Tamworth Solar Farm

Response to Request for
Information 29/4/20

Prepared for: Tamworth Solar Farm Pty Ltd
May 2020

This document contains Tamworth Solar Farm's response to a request for additional information from the Department of Planning, Industry and Environment dated 14th April 2020 as well as additional requests on the 4th, 7th and 12th of May.

Date: 18.03.20		Scale: 1:250 A1		Designed: AS		Project No		
Cad Ref: HD284 OXLEY HIGHWAY INTERSECTION R5				HD284				
4	ADD BAR AND BUS BAY			AS	18.05.20		Drawing No	Revision
3	ADD BUS BAY			KU	28.04.20			
5	WIDEN BUS BAY			KU	22.05.20			
No	Amendment			Drawn	Date		INT02	5

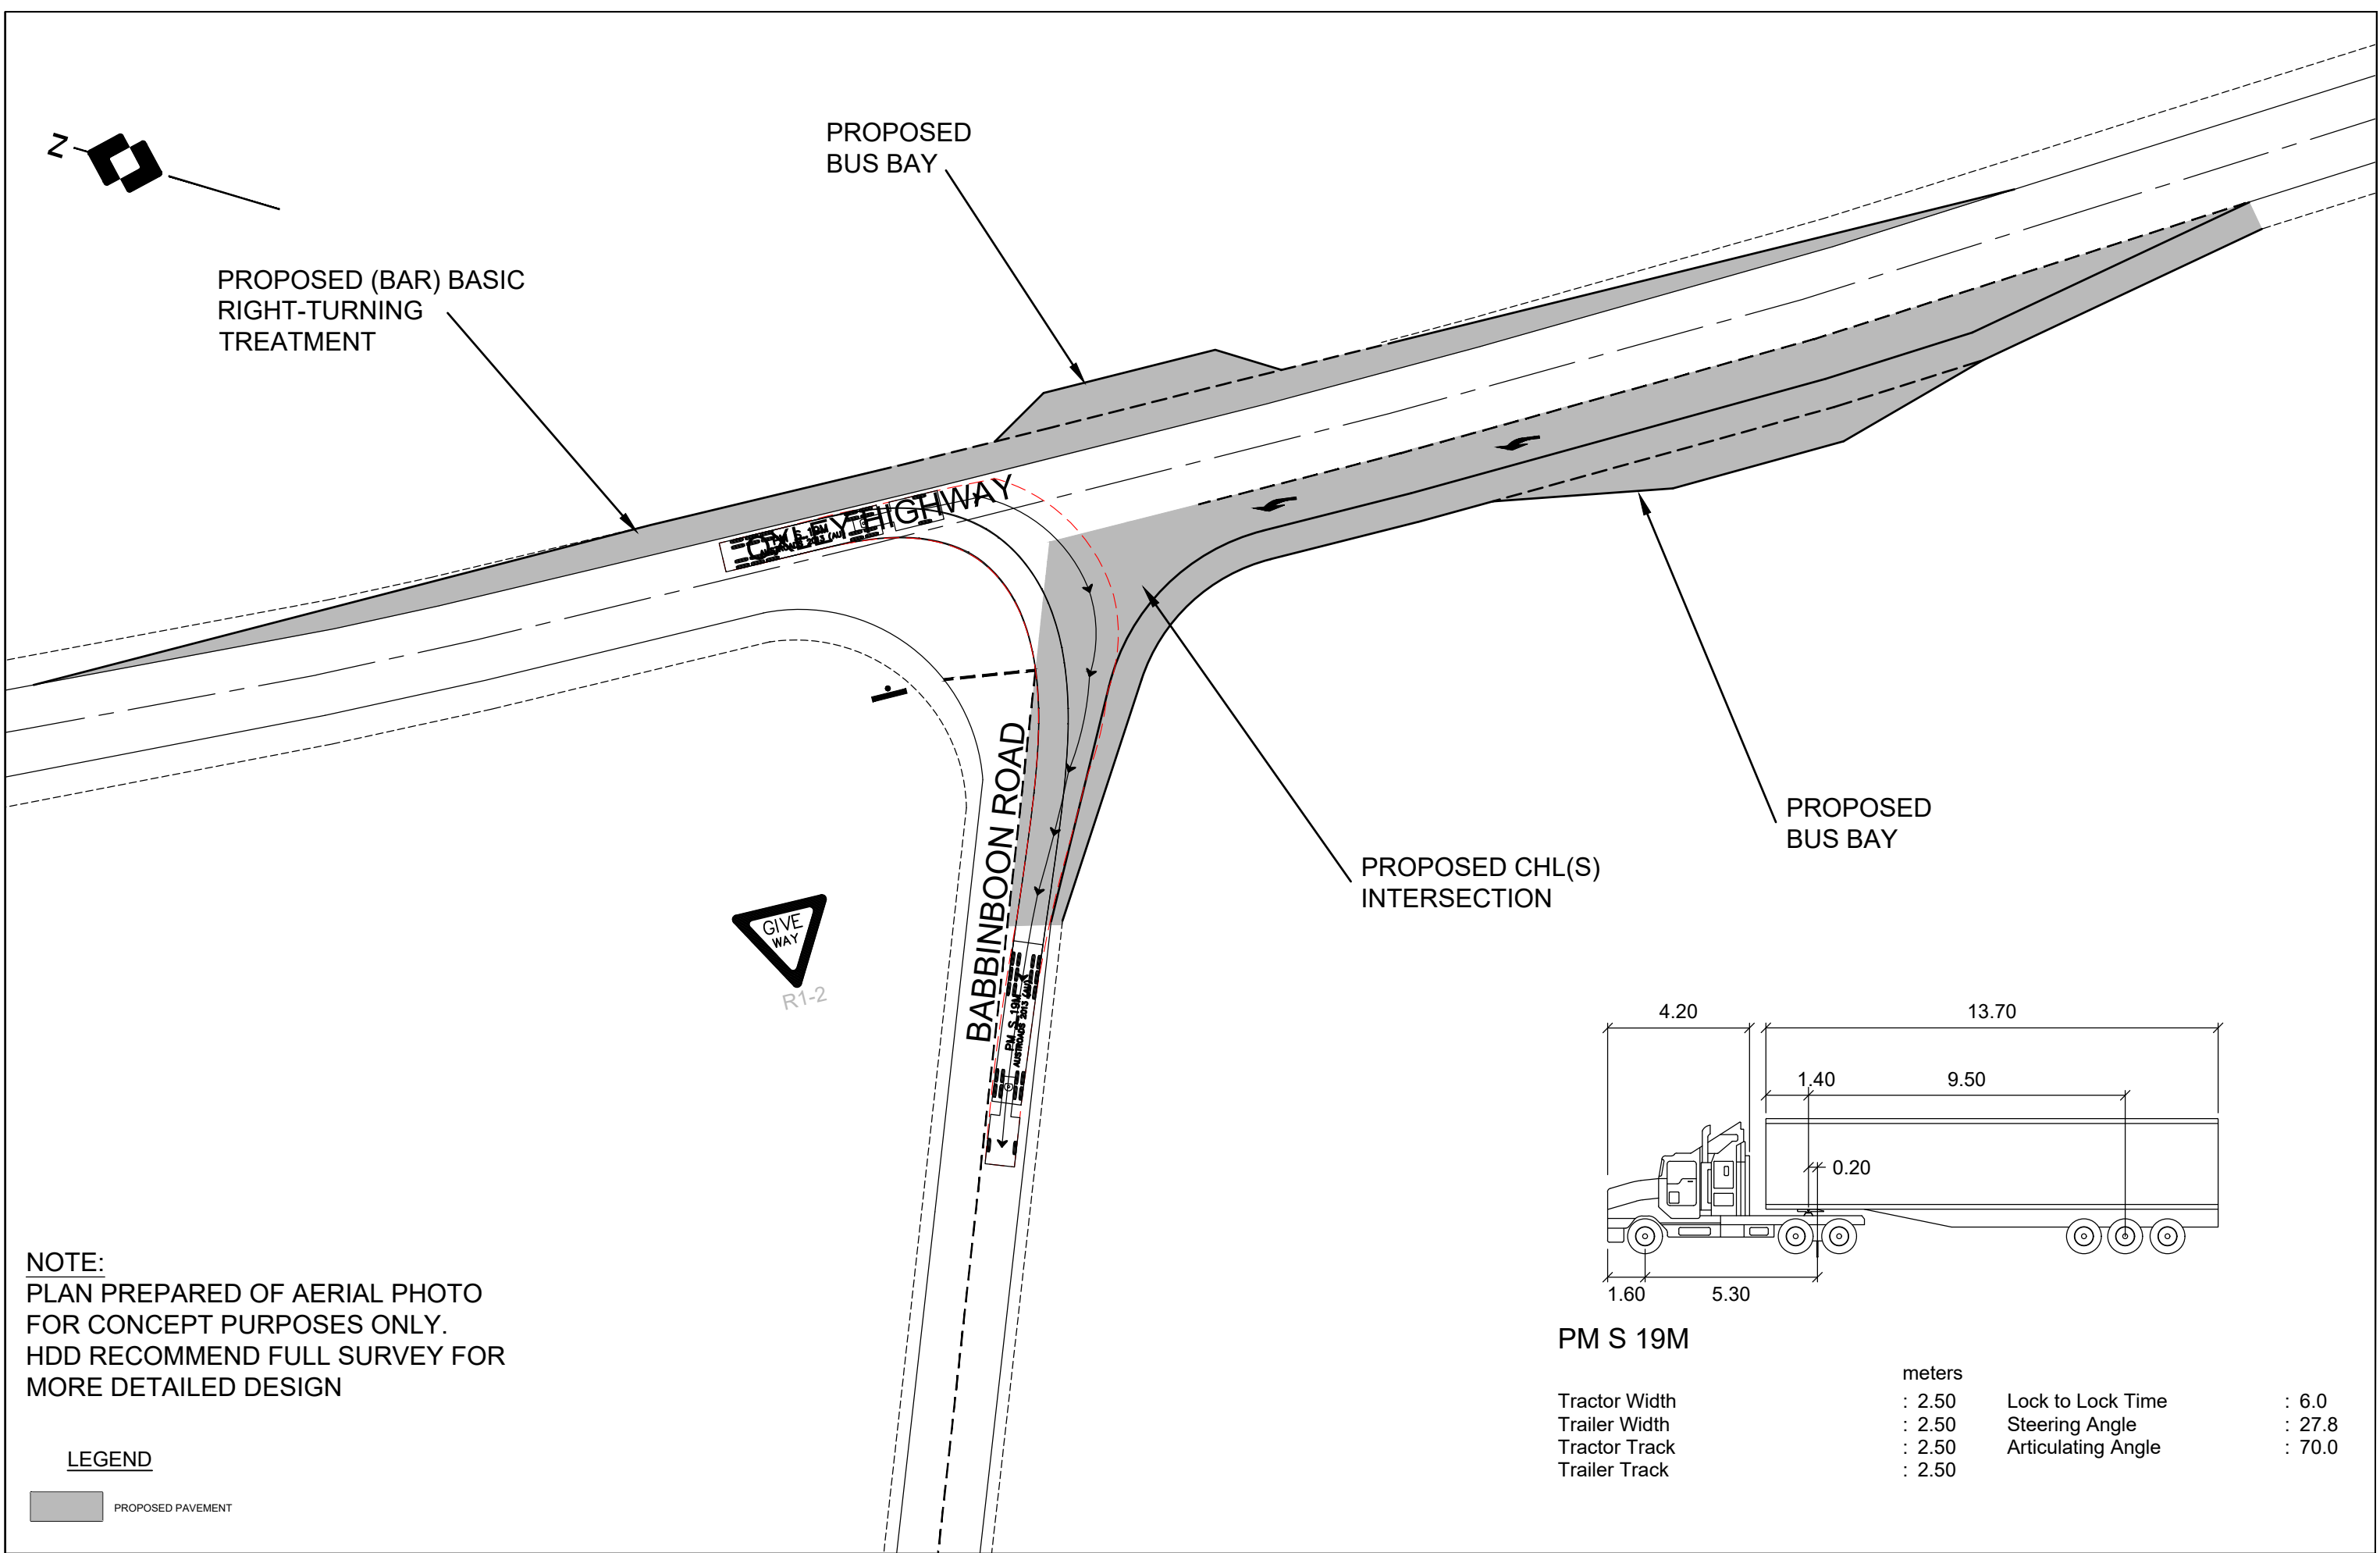
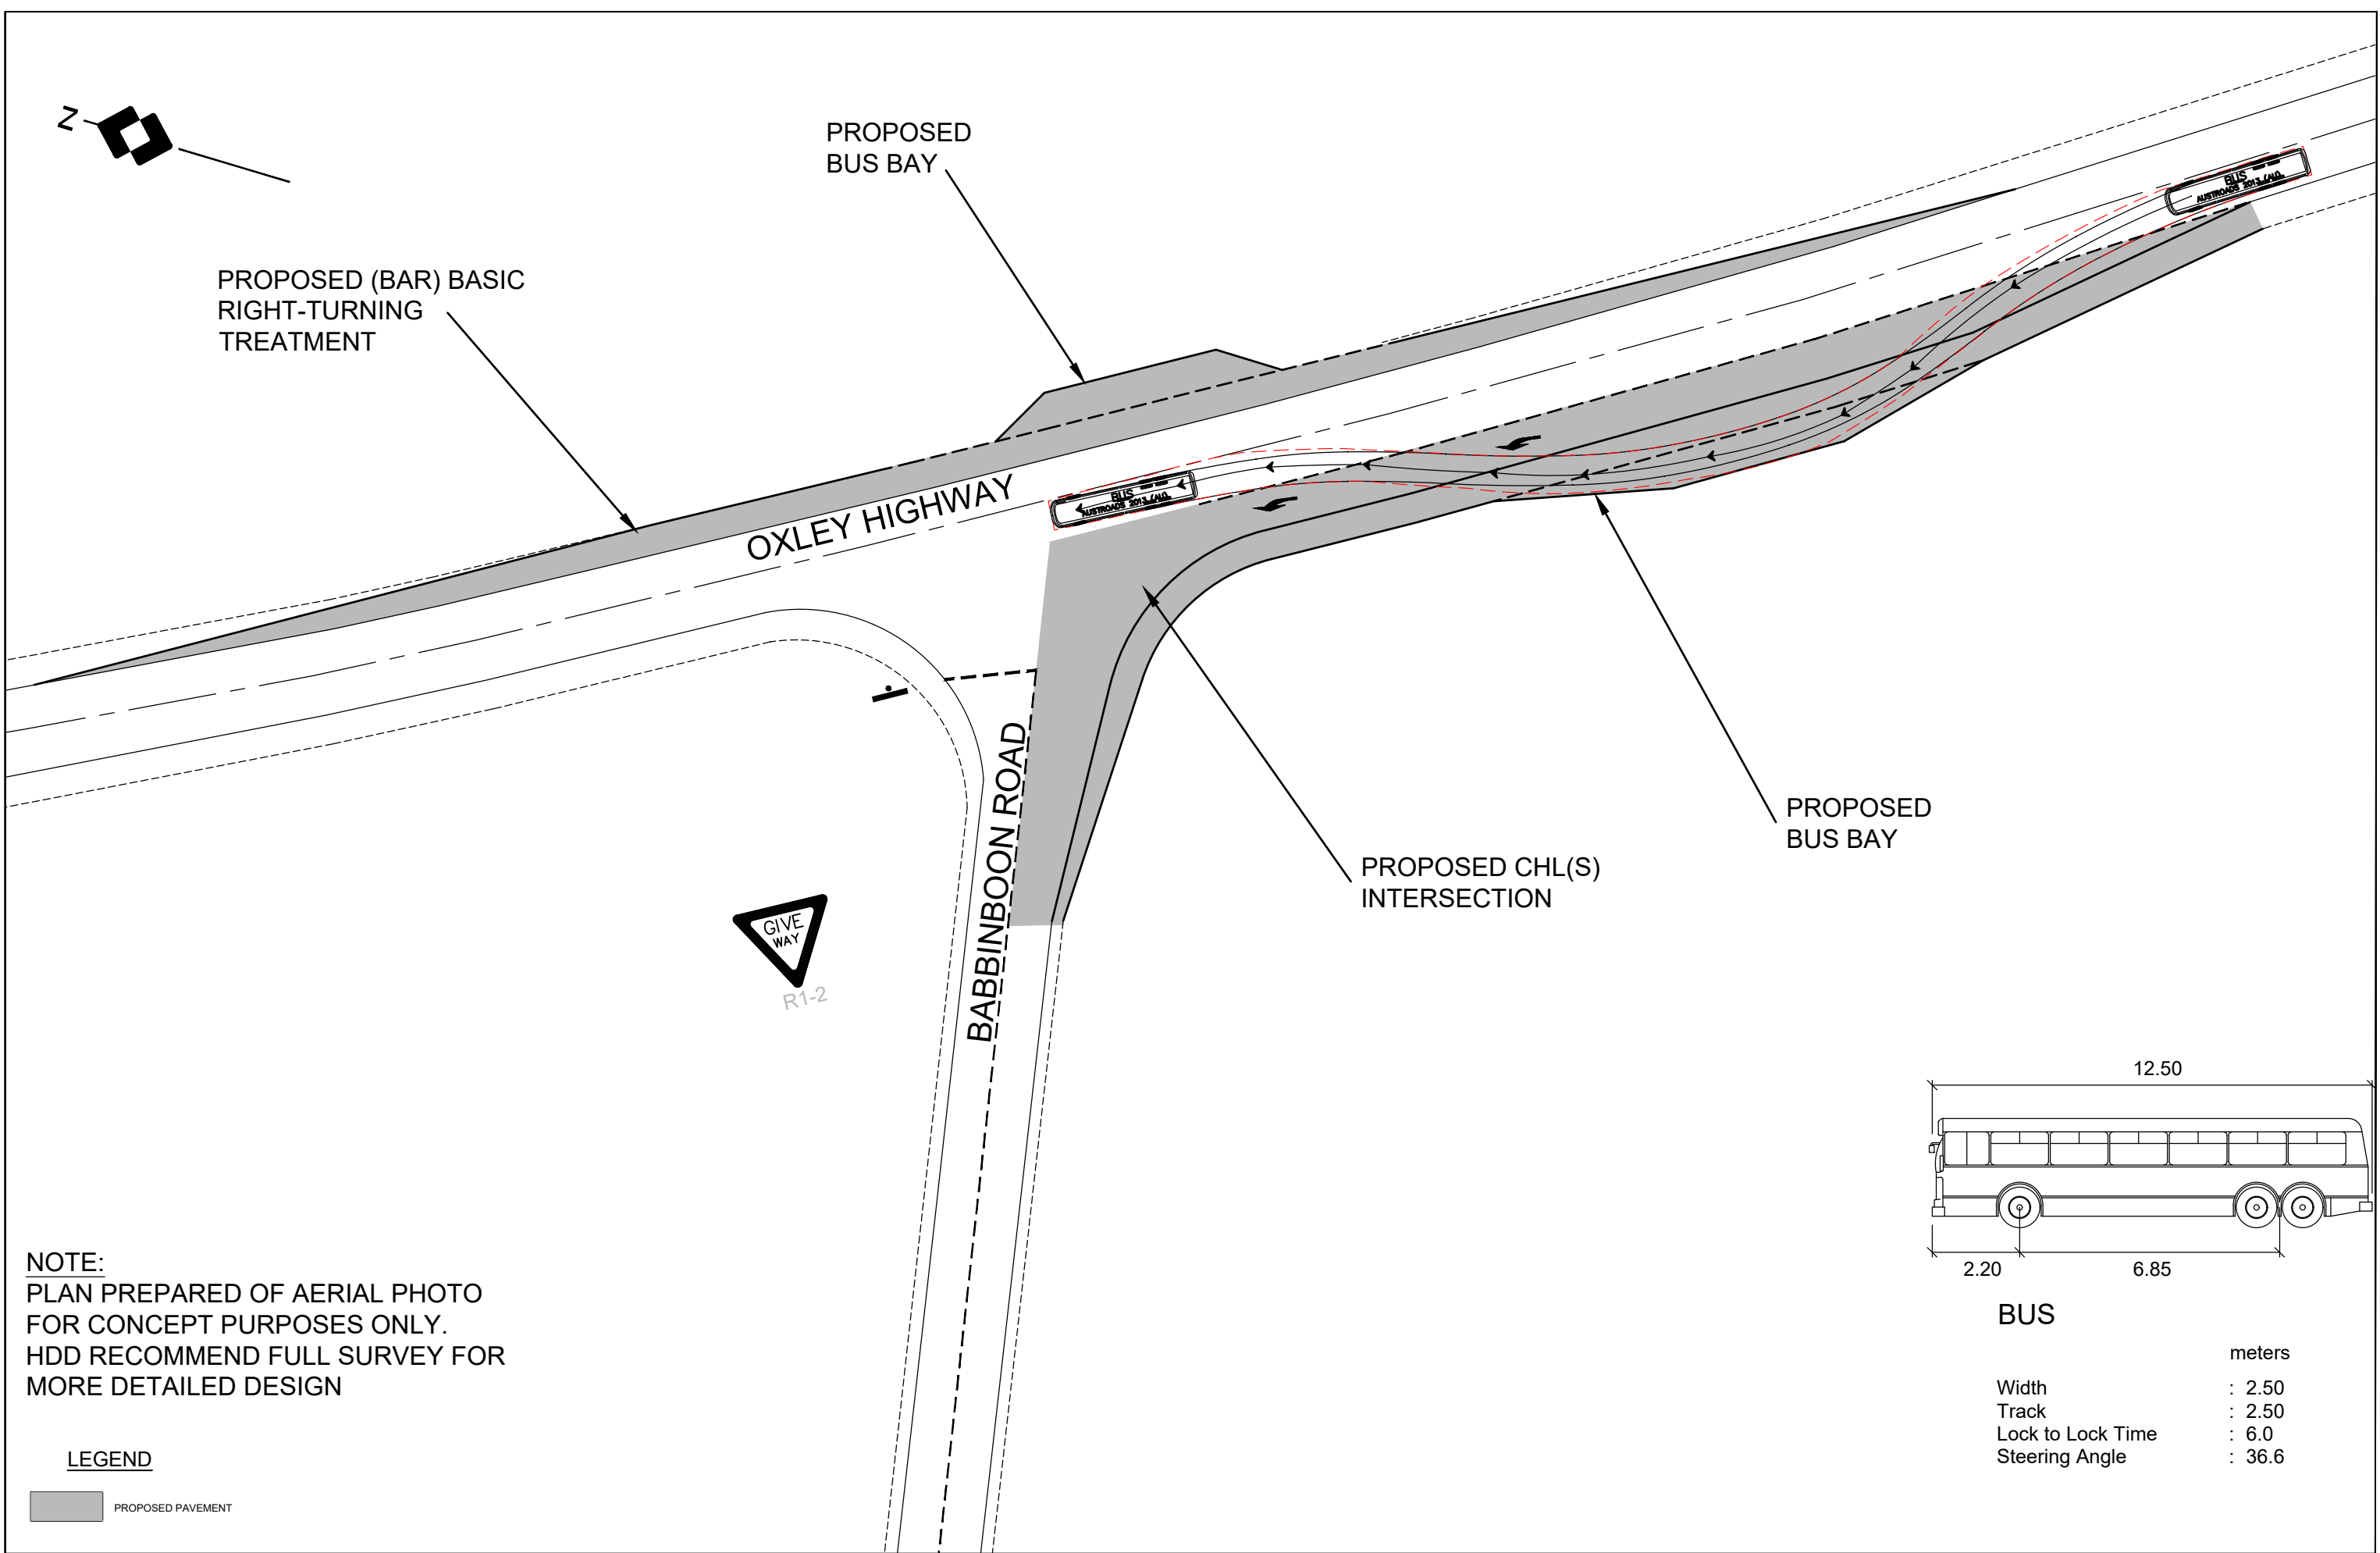
Requested Information: *"Clarify the nature and location(s) of the intersection upgrades and intersection treatment types and include a swept path diagram for the largest vehicles travelling to and from the site."*

The intersection of the Oxley Highway and Babbinboon Road is being upgraded to include a deceleration lane for vehicles turning left into Babbinboon Rd. Based on the discussions with TfNSW and on their request, a Basic Auxiliary Right (BAR) treatment is being provided at the intersection. Furthermore, two new bus stops will be provided that will give a much greater level of safety than the existing bus stops. A concept plan for the upgrade and a swept path diagram for the largest vehicle is included as Appendix A. Further information on why a higher level of treatment is not required is provided in the Technical Design Note in Appendix F along with information on sight lines for the bus stops.

To provide better bus stop locations at the intersections, Tamworth solar farm will construct sealed bus stops as shown in Appendix A. These locations have been discussed with Macphersons Coaches and they think the sites are suitable. An email from Macphersons is provided in Appendix C. The request they made to have the bus stop on the northern side of the highway widened to 3.6m has been included in the concept design in Appendix A.
